Permit Application Review Report
Date: 6/4/2025

Project Name: Bunker Hills Regional Park Redevelopment

Project PAN: P-24-062

Recommendation: Approve with 2 Conditions and 4 Stipulations

Figure 2: Erosion and Sediment Control Plan

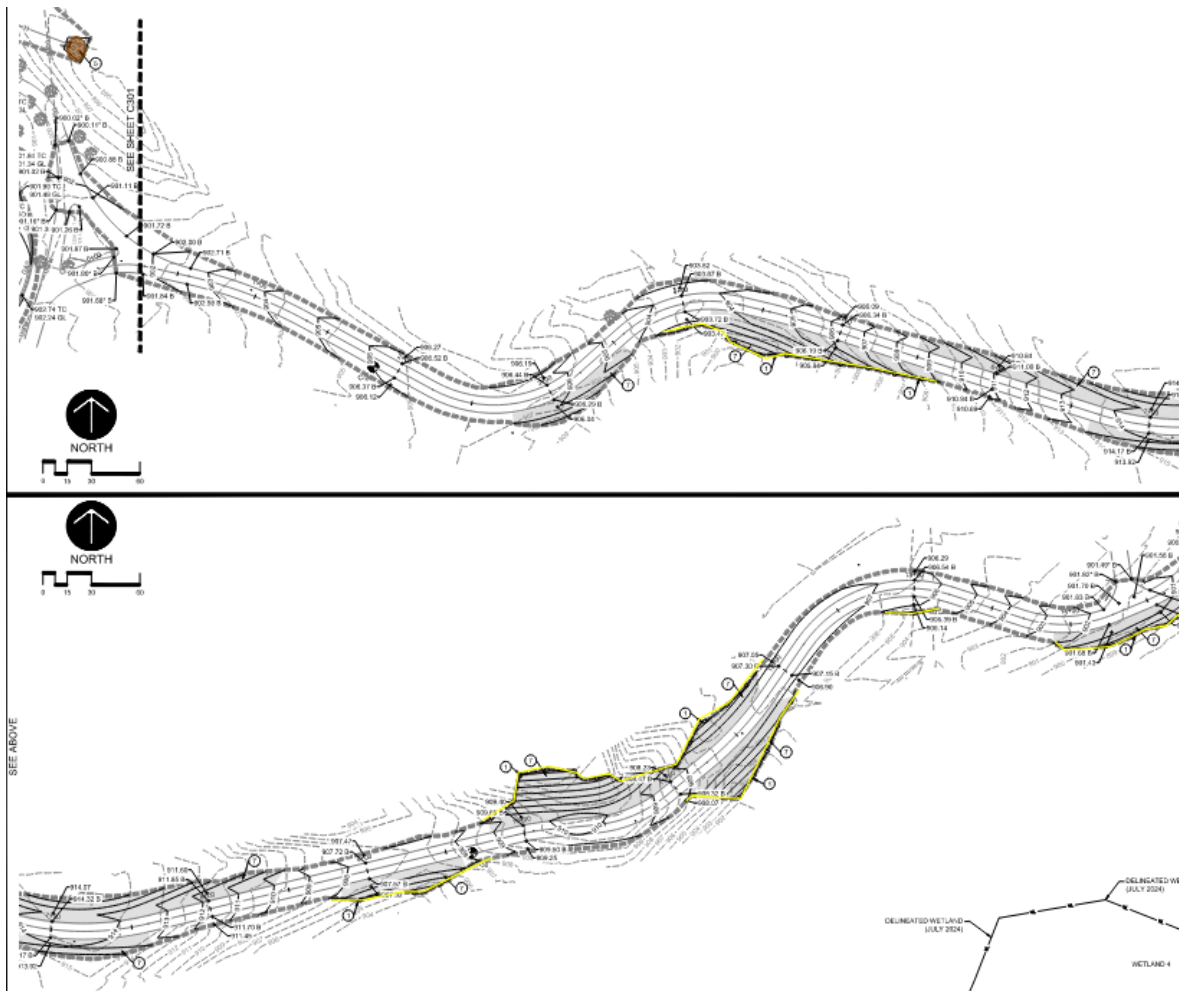
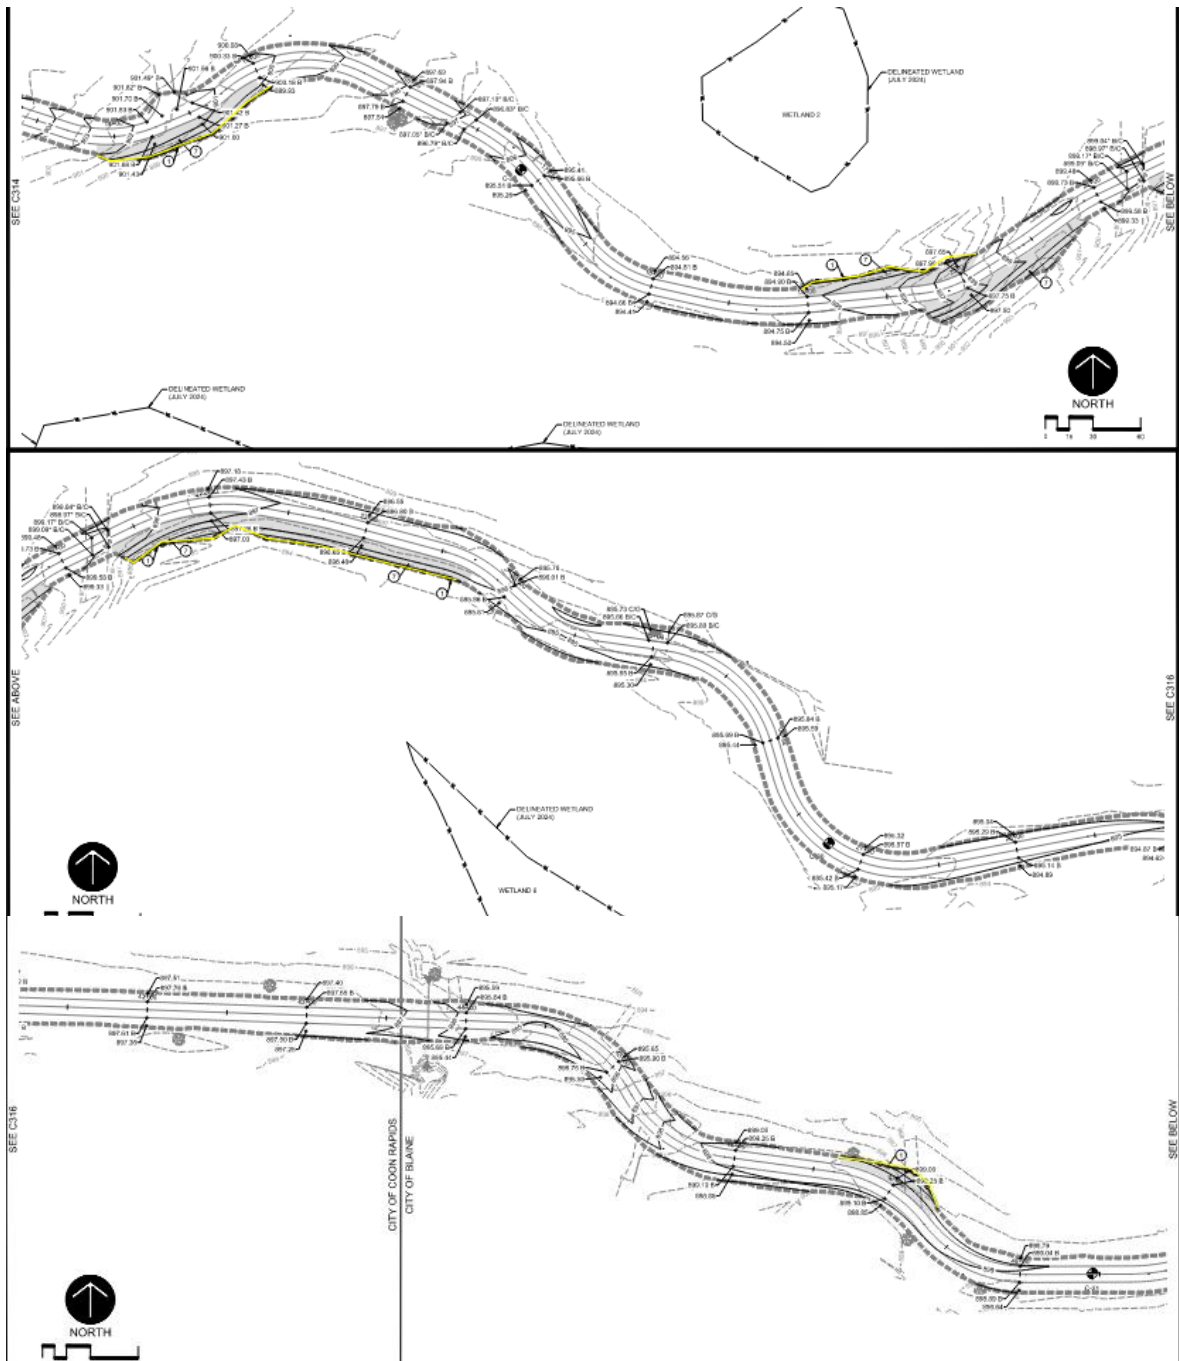
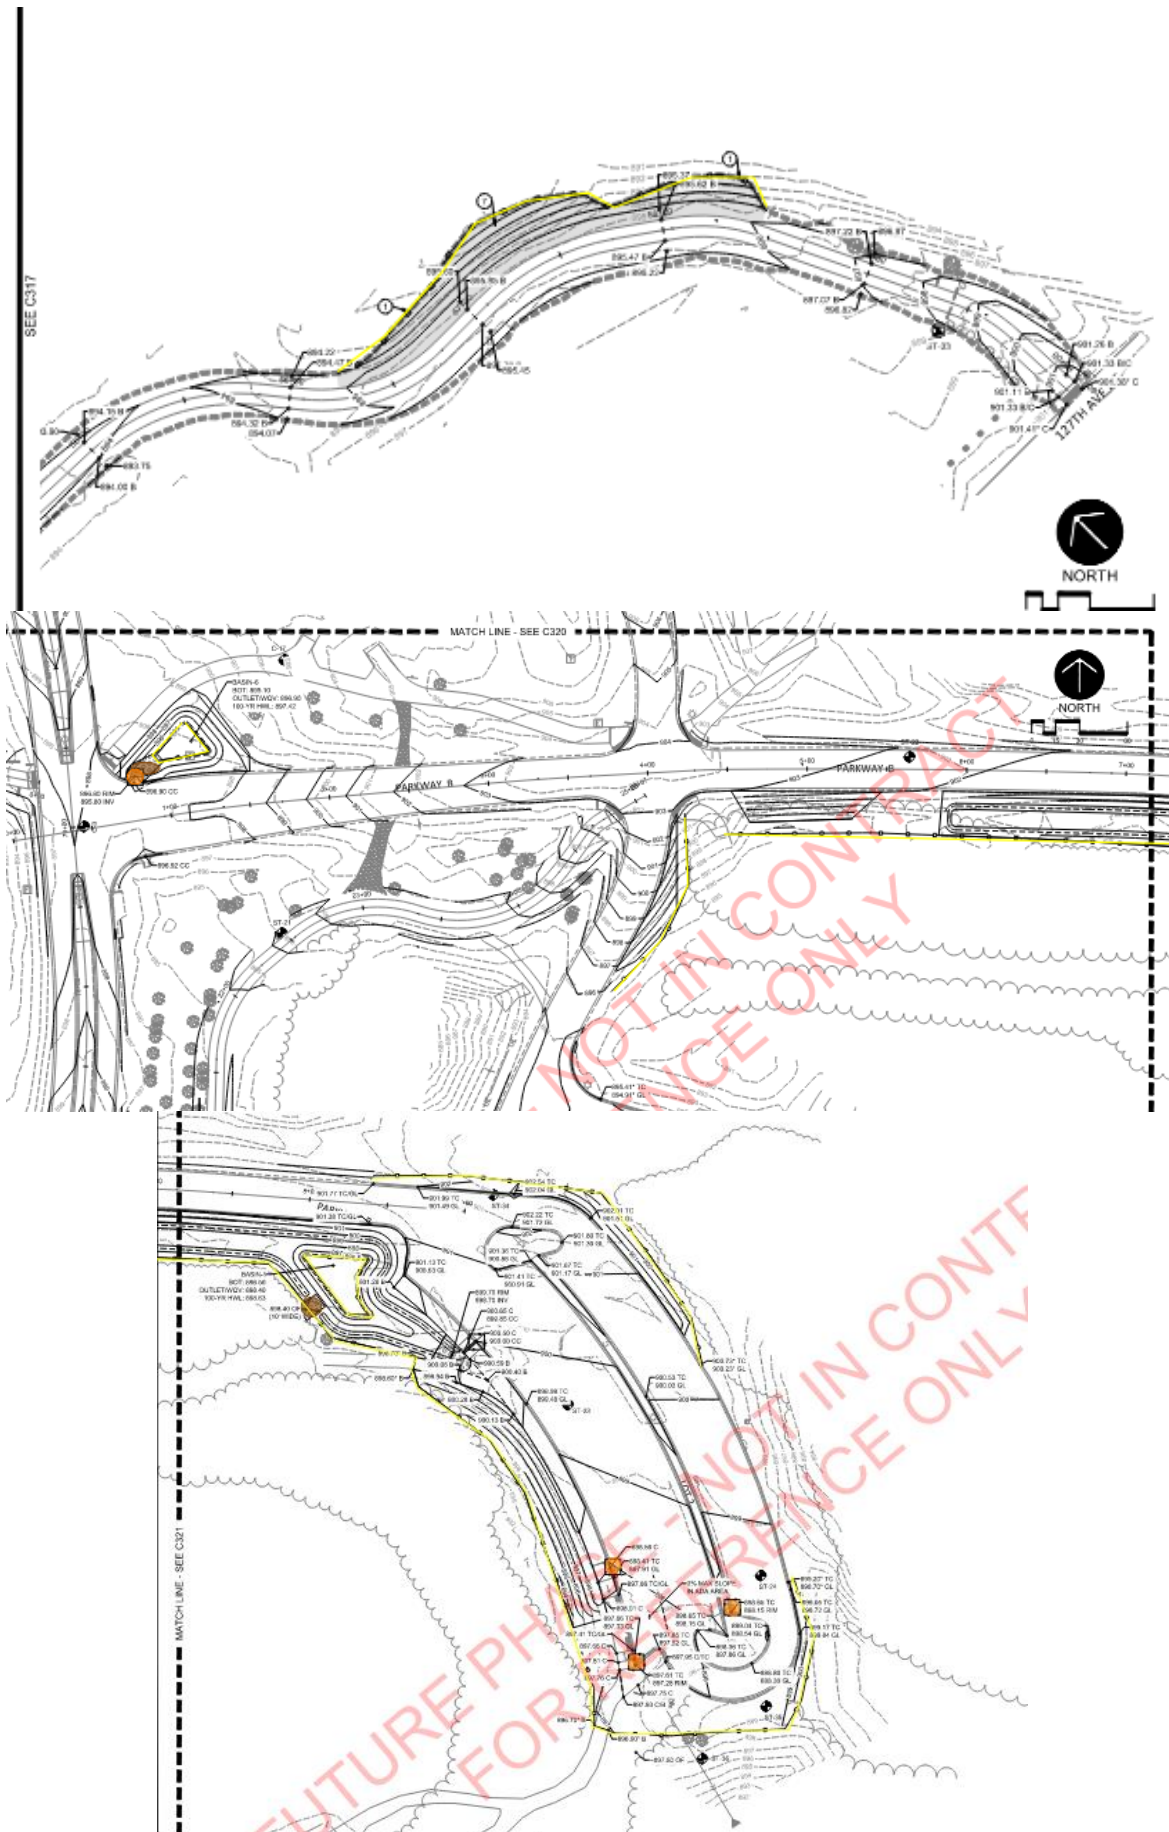
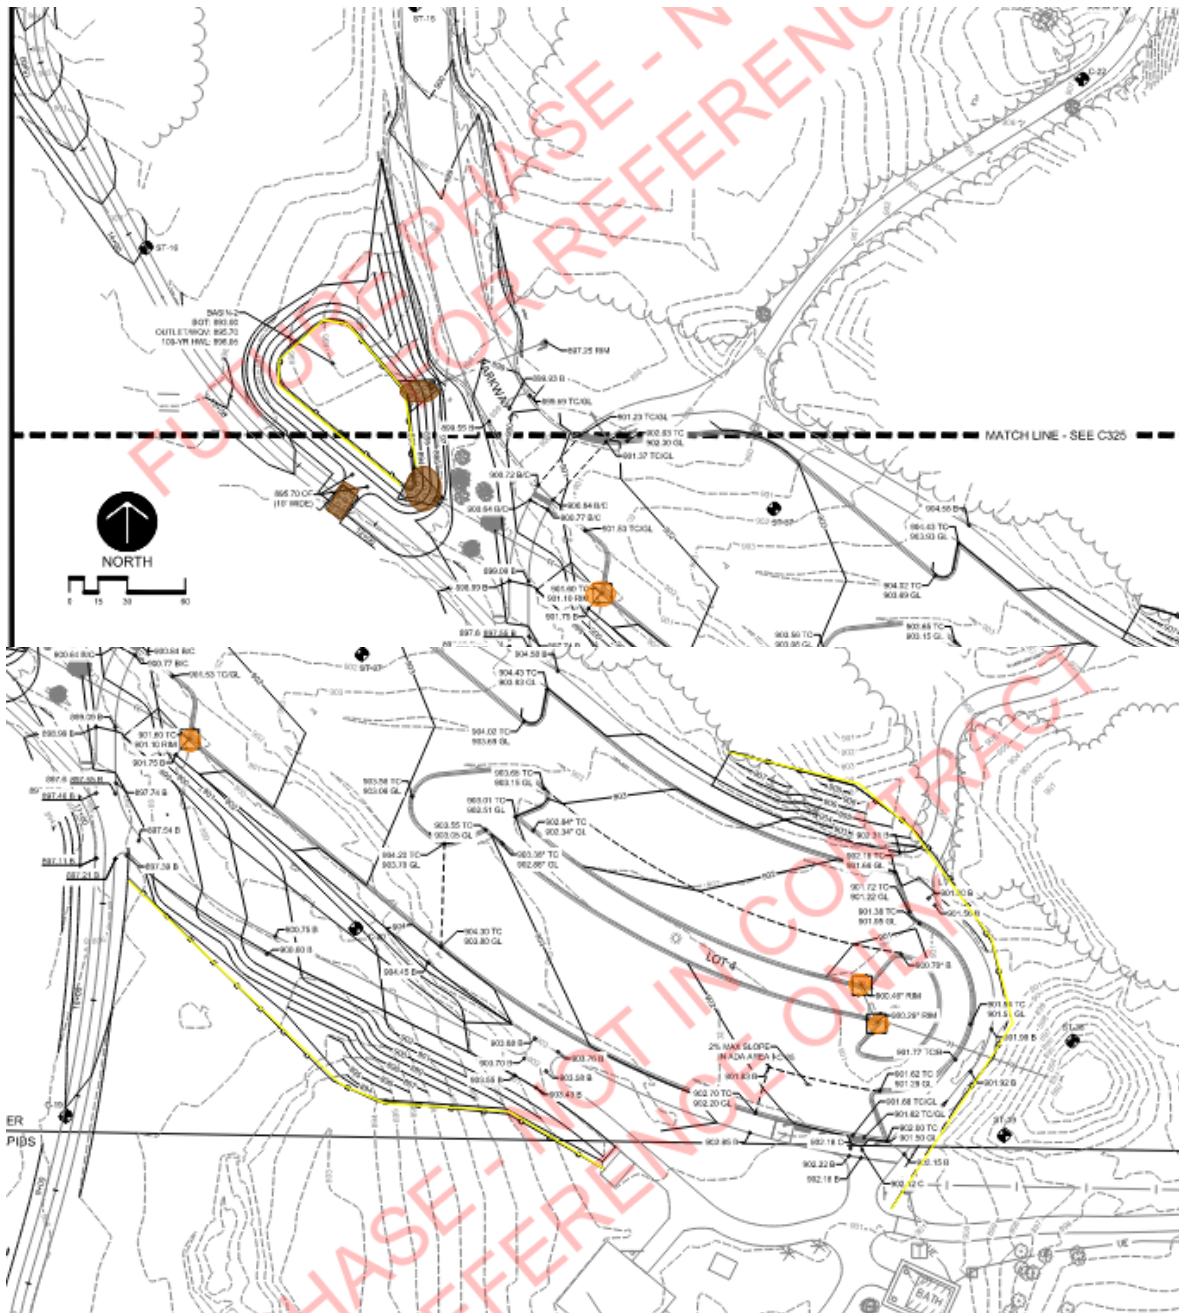
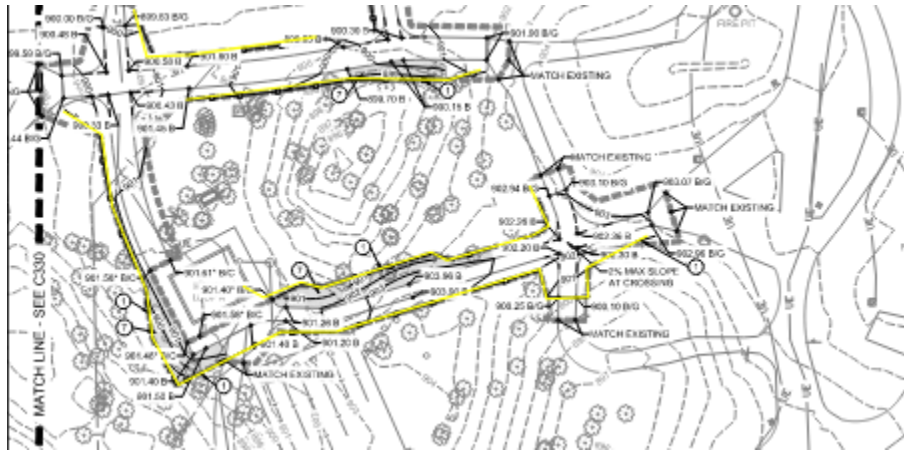
The proposed project drains to County Ditches 57, 54 and 23. The soils affected by the project include Sartell which do not have a soil erodibility factor of 0.15 or greater. Disturbed areas are proposed to be stabilized within 7 days, as required. The proposed erosion and sediment control plan includes inlet protection, perimeter control, stabilized construction entrance, and street sweeping. The erosion control plan meets District Requirements. The site does require an NPDES permit. See attached Figure 2 Erosion and Sediment Control Plan.
